IEEE802.3bt
LLDP adhoc

Meeting #2: Rev 002B, Tuesday June 20, 2017

LLDP concept review as agreed in D2.5 – Updated per the current text Proposal for a change marked in RED.

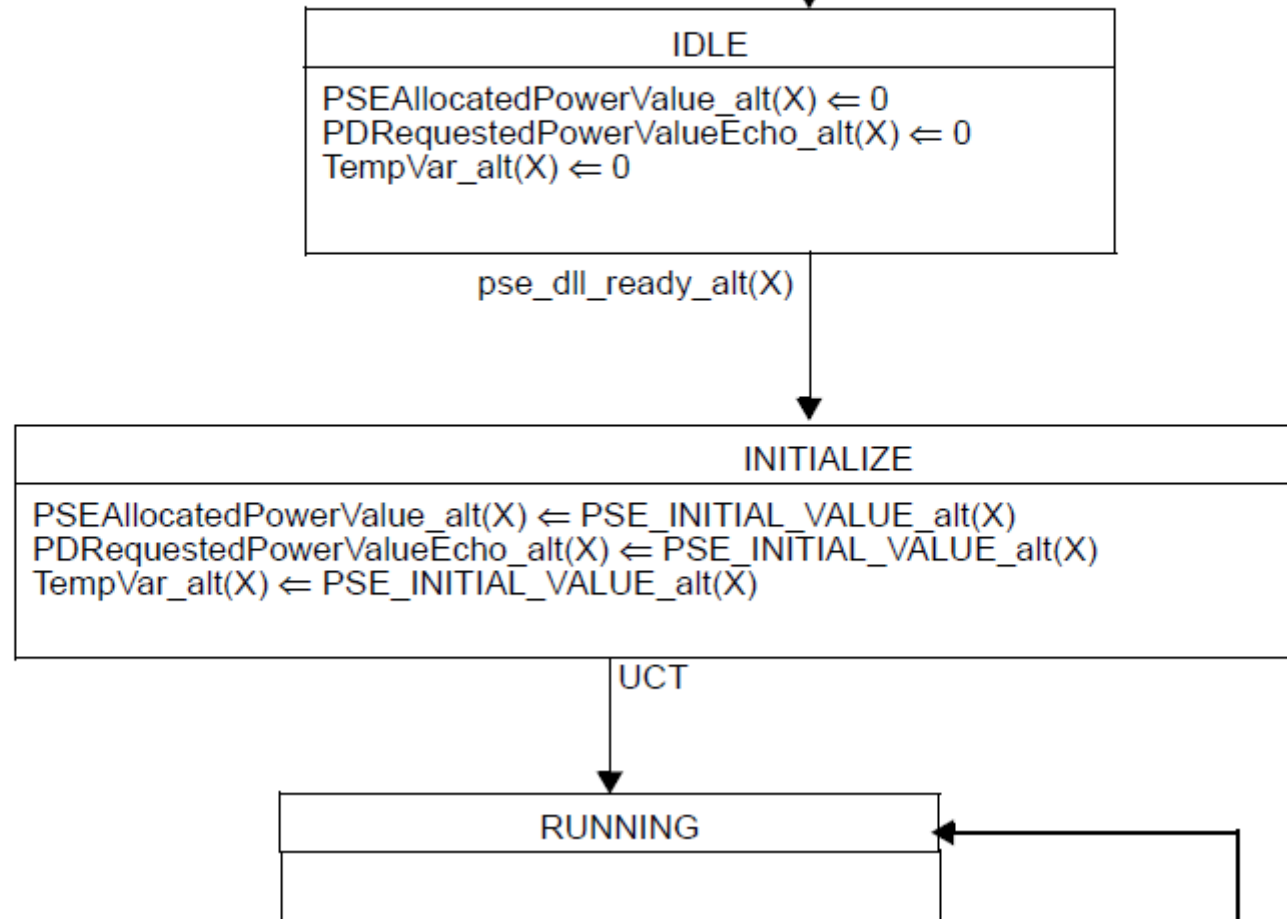
PSE	Use the following PSE fields	PD	Use the following PD fields
4-pair	PSE allocated power PSE allocated power Alternative (X)=0	Single-Signature. Type 1, Type 2	PD requested power PD requested power Mode (X)=0
Type 3 or 4. Operating over 2-pair.	<ul style="list-style-type: none"> PSE allocated power PSE allocated power Alternative (X). <i>Fill in 0 in the inactive field of PSE allocated power Alternative (X).</i> PSE allocated power = A+ B (**) <i>(or PSE allocated power =PSE allocated power Alt (X) where X is the active Alternative)</i> 	Dual-signature	<ul style="list-style-type: none"> <i>Fill in 0 in the inactive field of PD requested power Mode (X).</i> <i>(Delete to resolve #279)</i> PD requested power Mode A and B. PD requested power = A+B (**) <i>(To replace with Y=mode(X) where X is the active mode)</i>
Type 1 or 2. Operating over 2-pair.	<ul style="list-style-type: none"> PSE allocated power (*May) PSE allocated power = PSE allocated power Alternative A + B (**) <i>(Lennart suggest to set to zero.</i> <i>Yair: If PSE allowed to use this fields, it is better to use PSE allocated power =PSE allocated power Alt (X) where X is the active Alternative))</i> 	Dual-signature	<ul style="list-style-type: none"> <i>Fill in 0 in the inactive field of PD requested power Mode (X).</i> <i>(Delete to resolve #279)</i> PD requested power Mode A and B. PD requested power = A+B (**) <i>(To replace with Y=mode(X) where X is the active mode)</i> PD requested power Mode B (**)

Operating over 4-pair.	<ul style="list-style-type: none"> PSE allocated power Alternative A and B PSE allocated power = PSE allocated power Alternative A + PSE allocated power Alternative B <i>(Lennart suggest to set to zero)</i> 	Dual-signature	<ul style="list-style-type: none"> PD requested power Mode A and B PD requested power = PD requested power Mode A + PD requested power Mode B <i>(Lennart suggest to set to zero)</i>

(**) Why we need Y=A+B, see Annex and see alternative solutions i.e. PSE allocated power =

PSE allocated power Alternative X and PD requested power = PD requested power Mode (X) when X is the active pairs.

Comment #297 D2.4 (Page 75 line 12 in D2.5) - Figure 145-44
 Proposal for a change marked in RED.

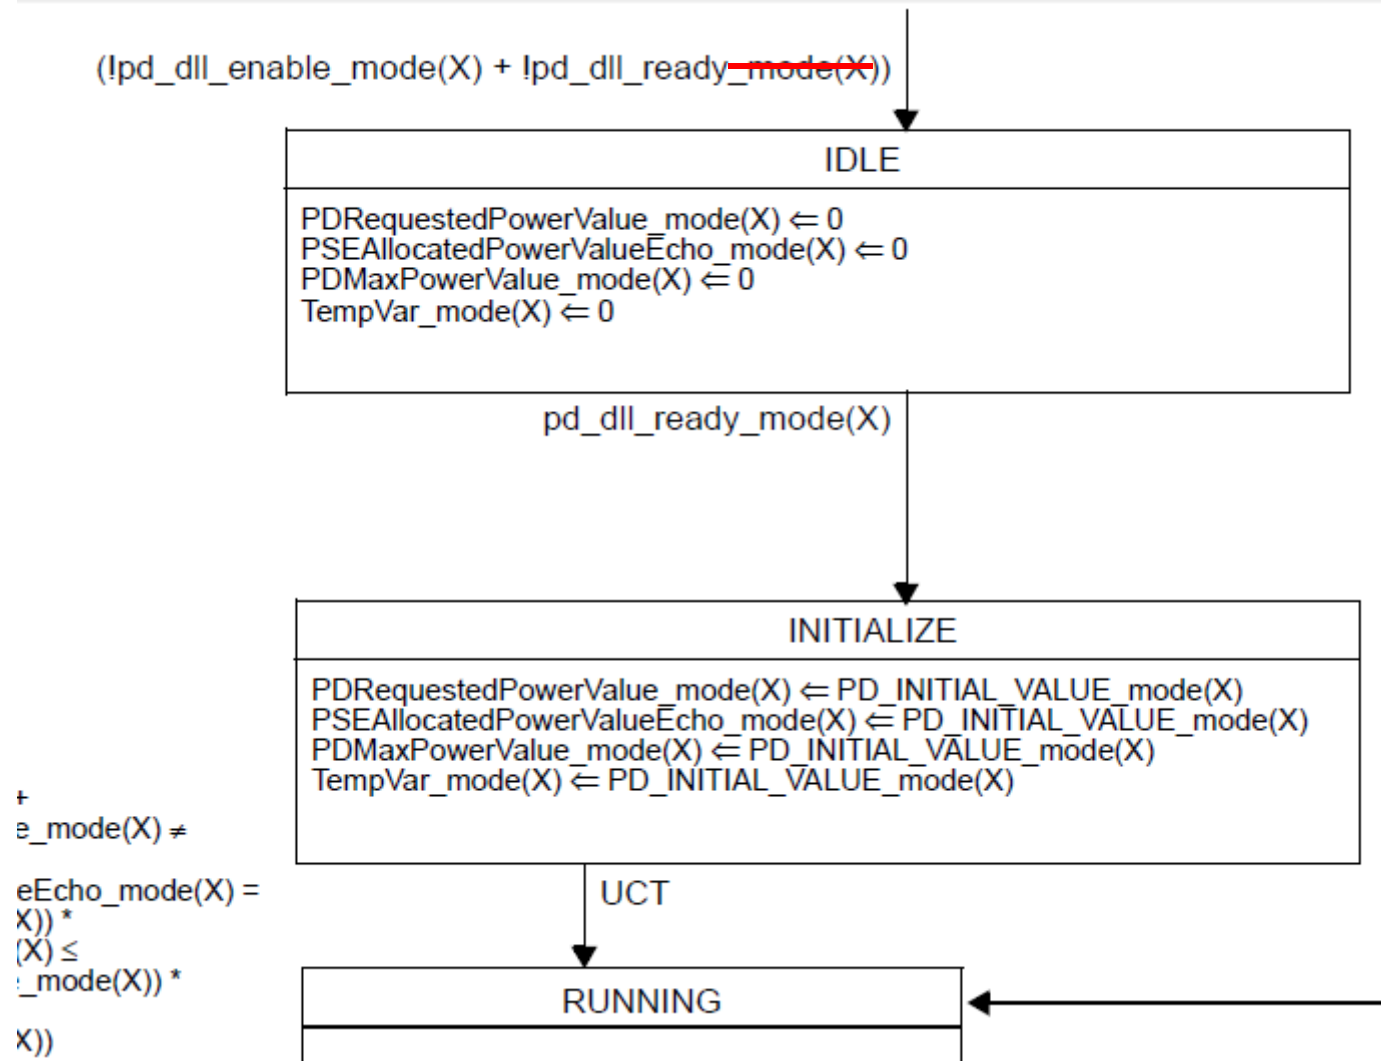
Comment #297 D2.4 (Page 75 line 12 in D2.5) Figure 145-43

$(!pse_dll_enable_alt(X) + !pse_dll_ready_alt(X)) * (sig_type = dual)$

- We have the information of total available power in the field “PSE maximum available power” in 79.3.2.6e. This resolve argument #2 in Annex A.
- To resolve #297, Lennart suggests: In order to request power on the unpowered pairset, see proposed changes in the red text. In addition, the `pd_dll_ready_mode(X)` need to be changed to `pd_dll_ready` to allow progressing to the INITIALIZE state in case PD want power on the unpowered pairset. No changes required in the PSE portion.

- Yair it will work:
 - To change from `pd_dll_ready_mode(X)` to `pd_dll_ready` in the PD state machine.
 - To change “if this mode/Alt is inactive, set to value 0” to “if this Alt is inactive, set to value 0” i.e. keep this requirement only to PSE.

- Lennart response: The proposed response to this comment is to adopt:
 - To change from `pd_dll_ready_mode(X)` to `pd_dll_ready` in the PD state machine.
 - To change “if this mode/Alt is inactive, set to value 0” to “if this Alt is inactive, set to value 0” i.e. keep this requirement only to PSE.
- **Group to discuss.**
